ADDENDUM No. 1

ITB No. 4433

FERDON WELLS STORM SEWER REHABILITATION PROJECT

Plans Sheets 4 & 7 These plan sheets shall be removed and replaced with the attached plans sheets #4 and 7. The significant changes to these plans sheets include the following:

SCALE: N/A
DRAWING NO.: 2014044-4
SHEET NO.: 4 OF 10

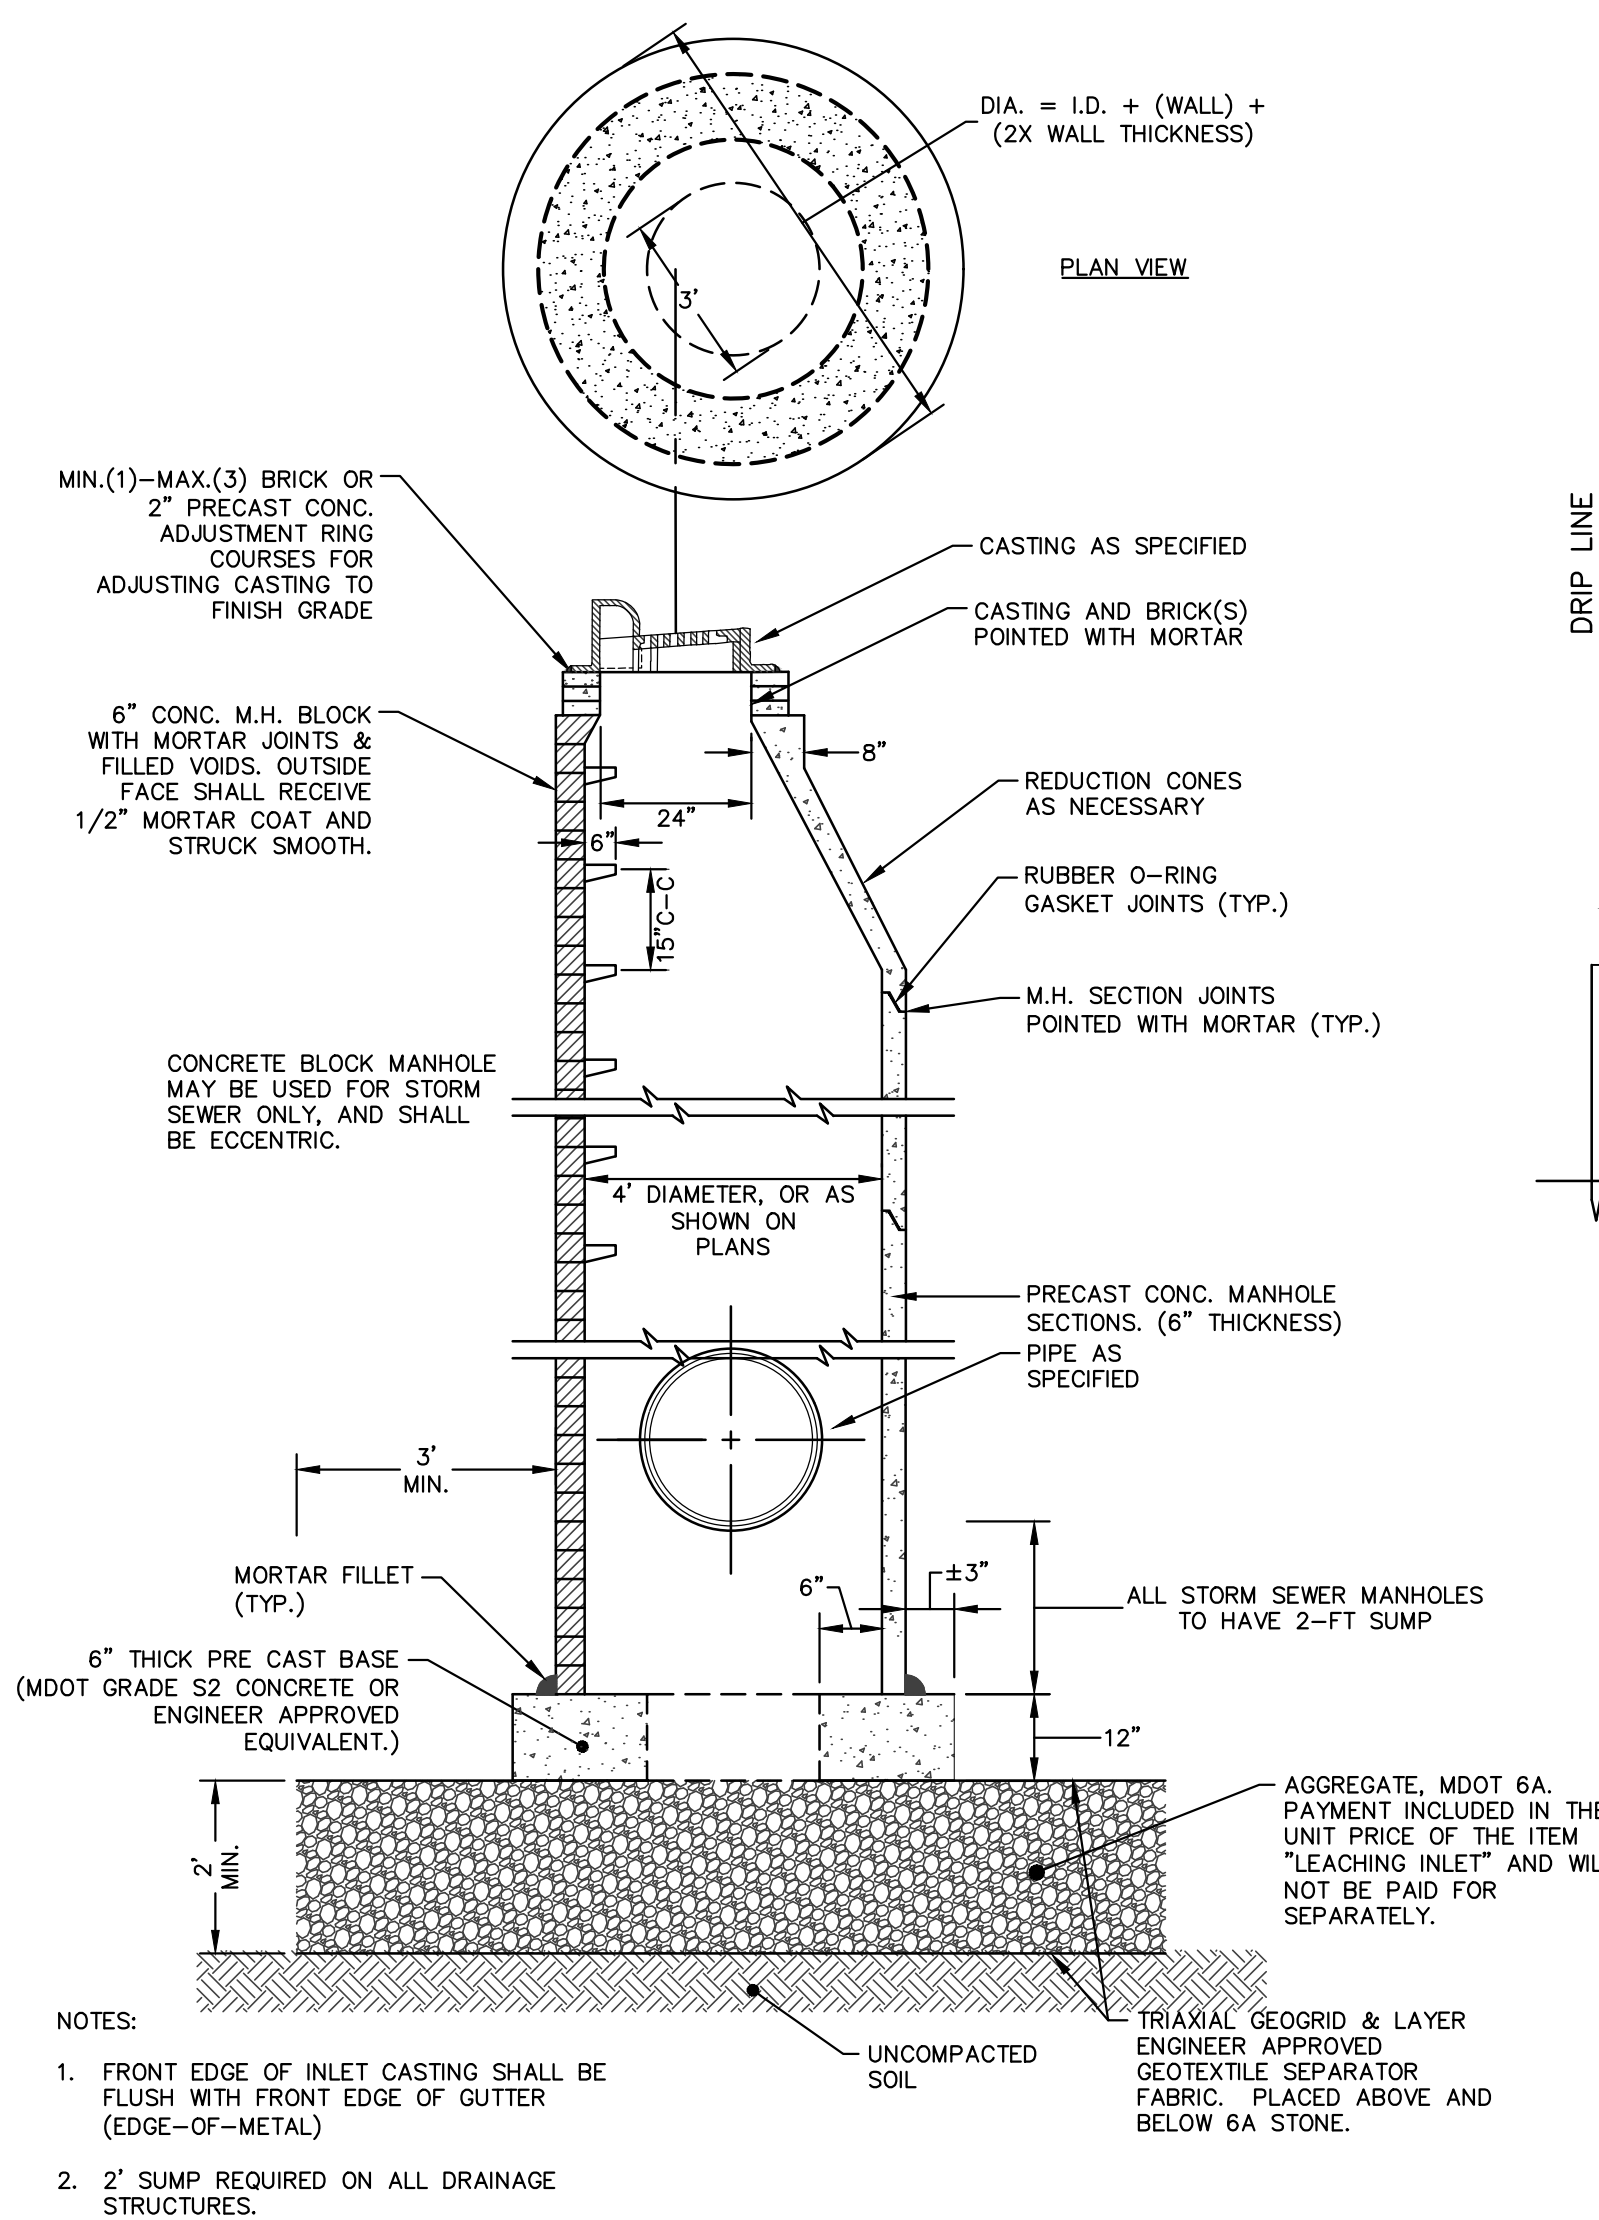
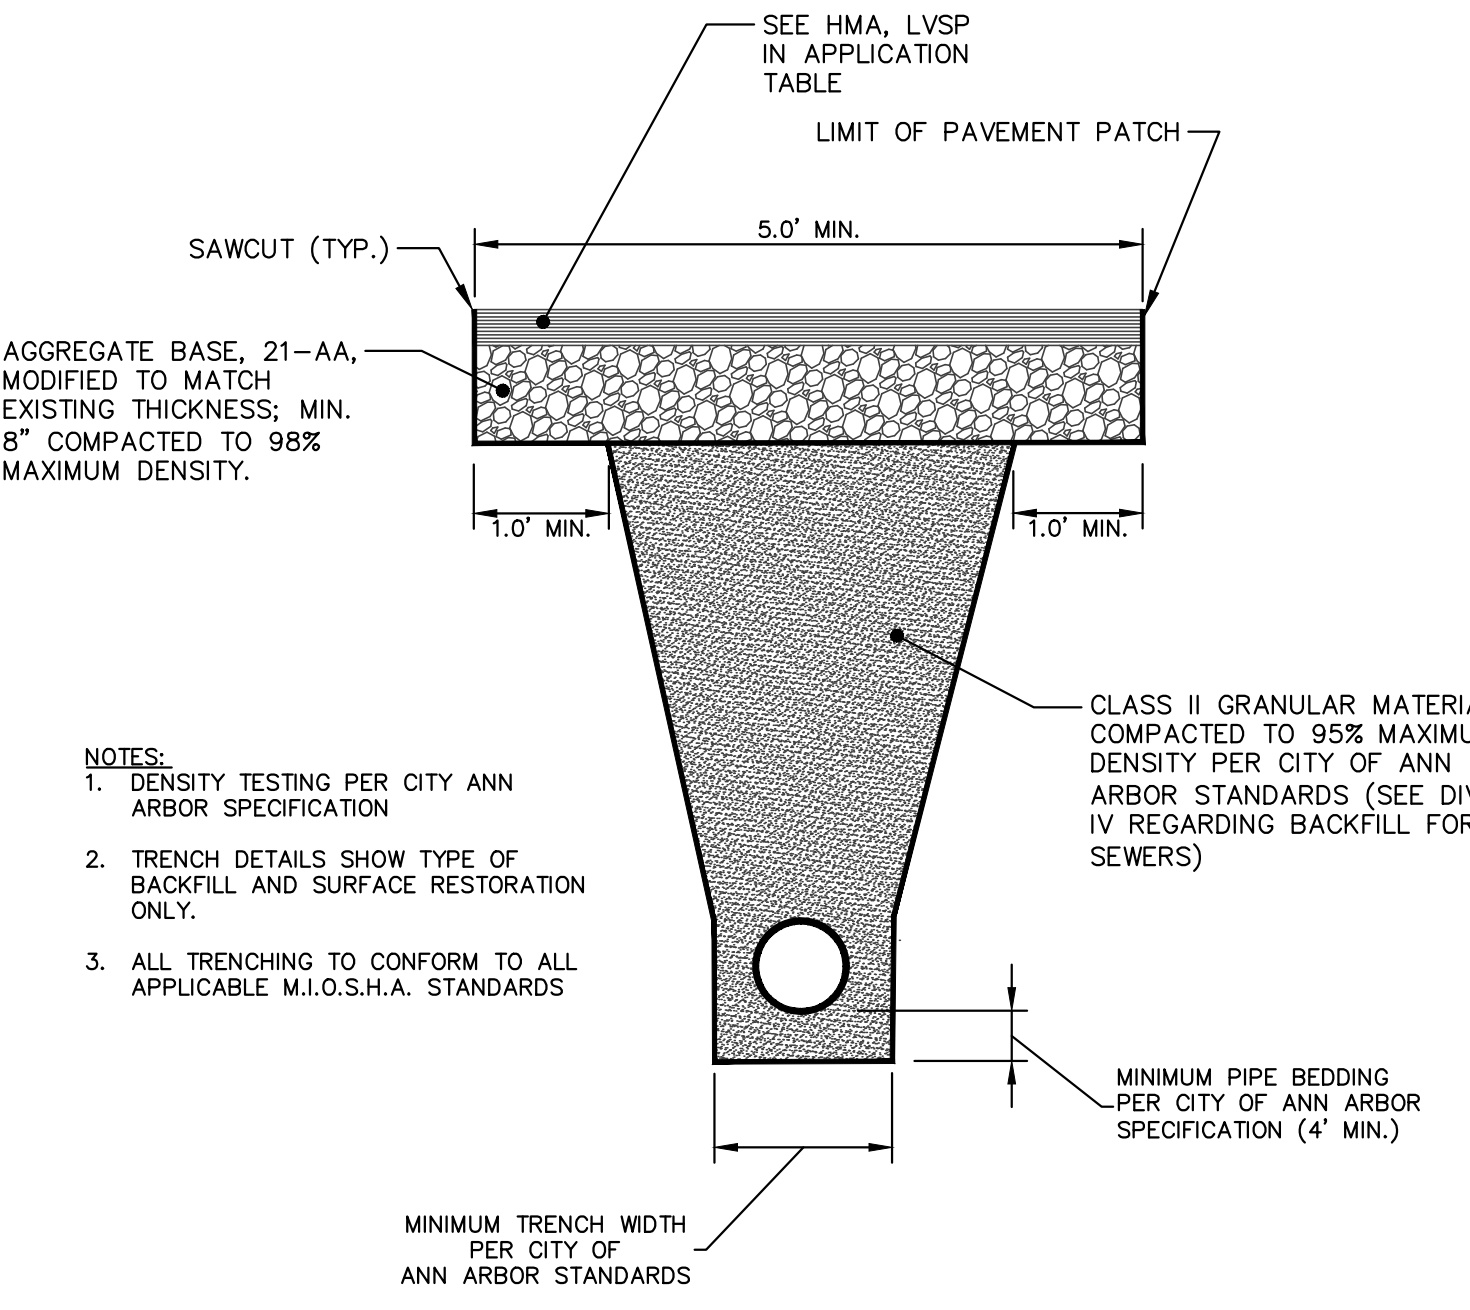
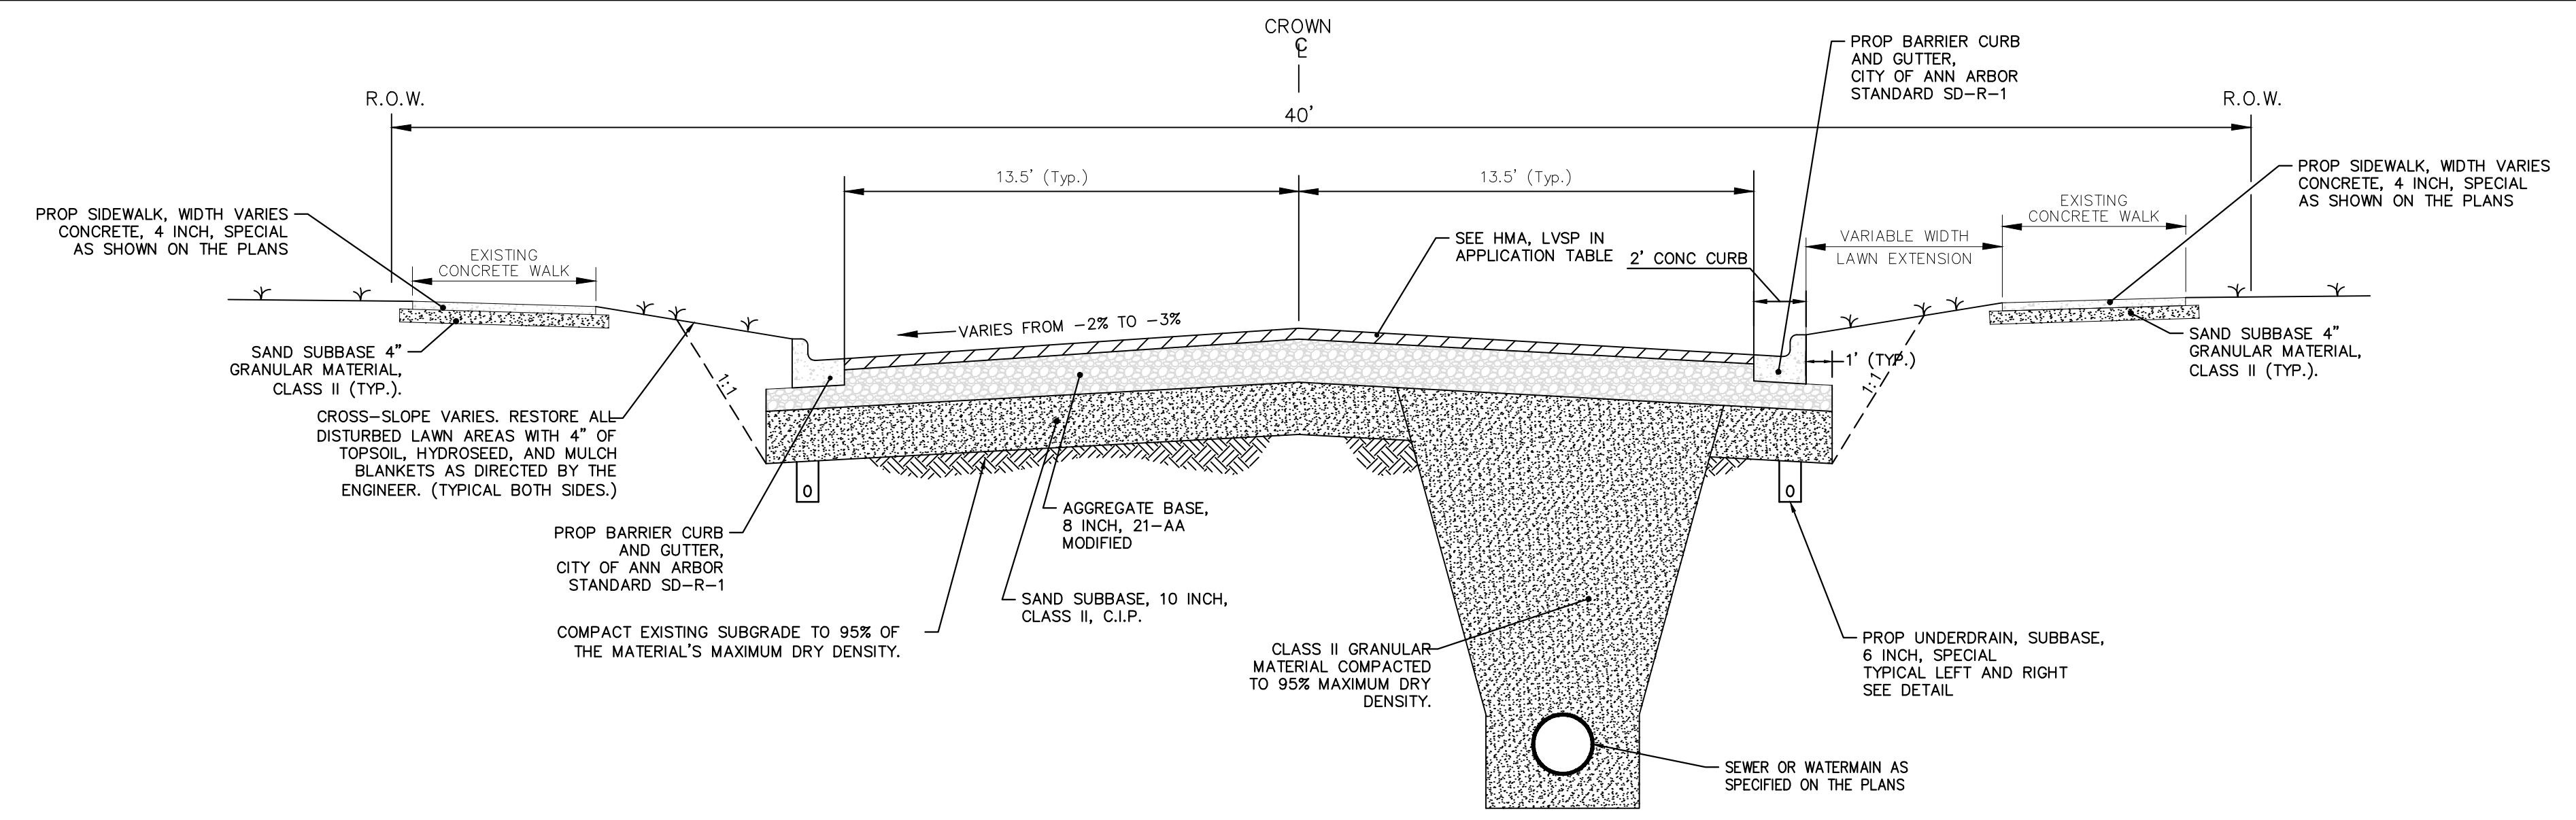
On plan sheet #4, the 10 inch sand subbase, CIP is shown to consist of MDOT Granular Material Class II, Modified.
